RE: Planning Board Response LandCare Associates

282 & 284 Knox Marsh Road

Tax Map 9, Lots 3 & 4

Based upon the memorandum received by Liz Durfee, AICP, dated September 14, 2022, Berry Surveying & Engineering (BS&E) offers the following responses and discussion in **bold:**

Existing Conditions Plan, Sheet #2 - Included in 8-29-22 submission

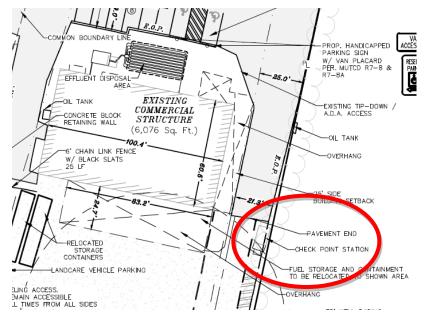
A safety review and appropriate permits for the shed and all utilities shall be
obtained through the Madbury Building Inspector and Fire Department. This
shed should be clearly labeled on the existing and proposed plan sheets.
 Enclosed is the location of the requested information for both sheets.

Existing Conditions Plan, Sheet #2 - Included in 8-29-22 submission

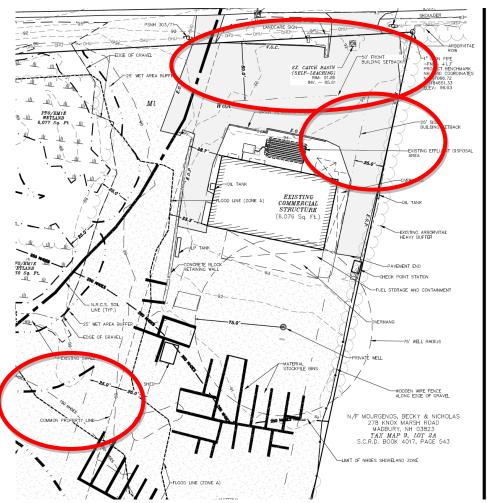
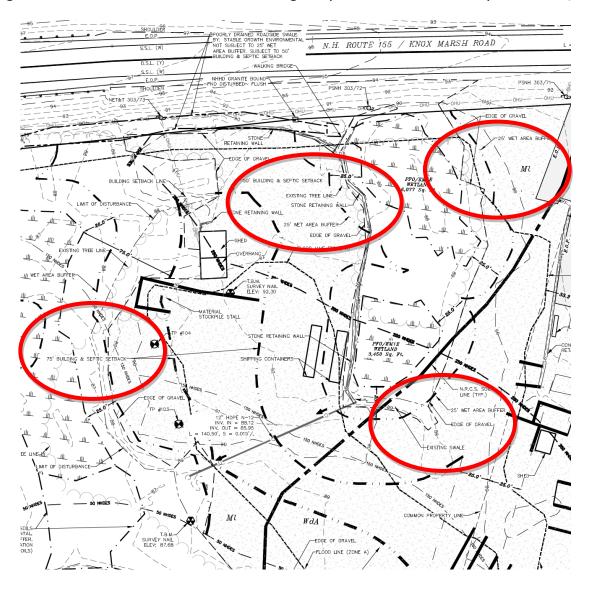
The Zoning Ordinance states that the minimum frontage requirement is 25 feet, however this is assumed to be a typo as the side setback requirement is 25 feet. It is assumed that the requirement is 125 feet. The Board should confirm this. It does not appear that Lot 3 has 125 of frontage. The frontage and setbacks need to be shown on both lots.

All applicable building setbacks are shown on both lots. Enclosed is the location of the requested information for both sheets.

Screenshot from Site Plan, Sheet #6 – Revised in 9-19-22 revision.

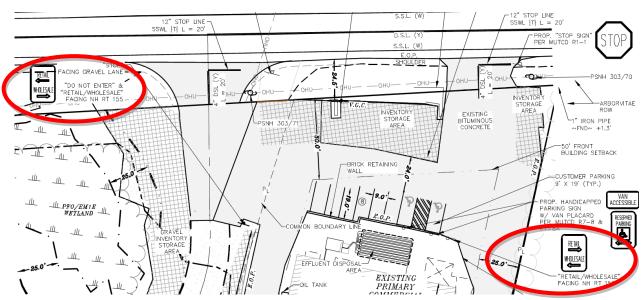
• During the site visit on 12/4/21 there was a discussion about clearly demarcating/defining the retail customer parking vs loading areas for safety reasons. This does not appear to have been added to the plan.

A wayfinding sign has been added to the Site Plan to better demarcate these activities.

Screenshot from Site Plan, Sheet #6 – Revised in 9-19-22 revision.

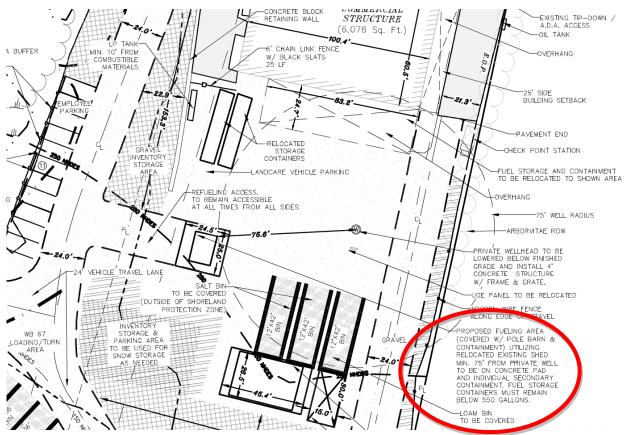
• The location and quantity of hazardous materials should be documented and a copy provided to the Fire Chief and the Planning Board.

No other hazardous materials are proposed on-site other than the 550 gallon maximum refueling station with containment, which is shown on the Site Plan. Small pint/quart size volumes are kept in the building for any other items needed for site operations.

Screenshot from Site Plan, Sheet #6 – Revised in 9-19-22 revision.

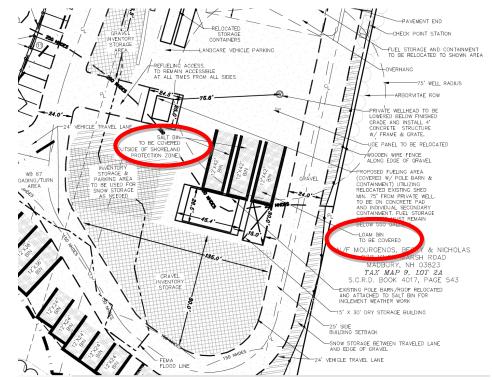
- Where are customers allowed? Will there be signage to direct the public?
 Please two earlier way finding sign responses.
- Specify categories of materials to be stored (i.e. soil, gravel, stone, salt, etc.).
 Loam and salt bins have been specifically called out and are to be located outside of the 250' NHDES shoreland zone. Gravel, stone, mulch, and other products that do not pose an adverse environmental impact are allowed within the bins and inventory storage areas and are likely to be moved from bin to bin from time to time.

Screenshot from Site Plan, Sheet #6 – Revised in 9-19-22 revision.

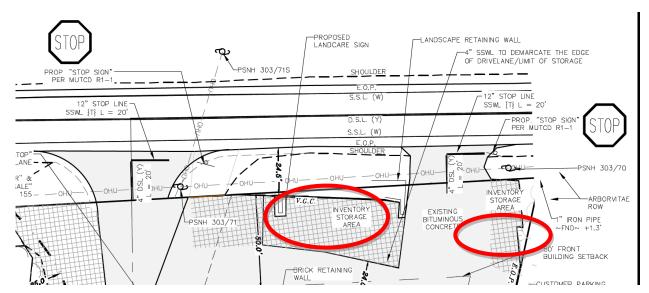
- The general inventory storage areas should be marked on the plan not just a label. Particularly around the front of the site where retail customers and traffic are expected and maintaining access for emergency vehicles is needed.
 Hatching has been added to the inventory storage area at the front of

- Hatching has been added to the inventory storage area at the front of the Site.

Screenshot from Site Plan, Sheet #6 – Revised in 9-19-22 revision.

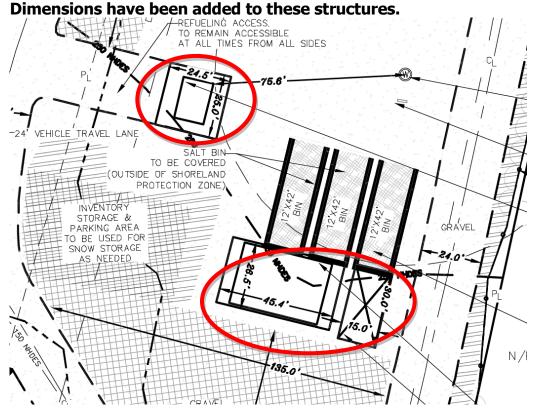
All dimensions of structures should be added to the plan (fueling, pole barn, etc.)
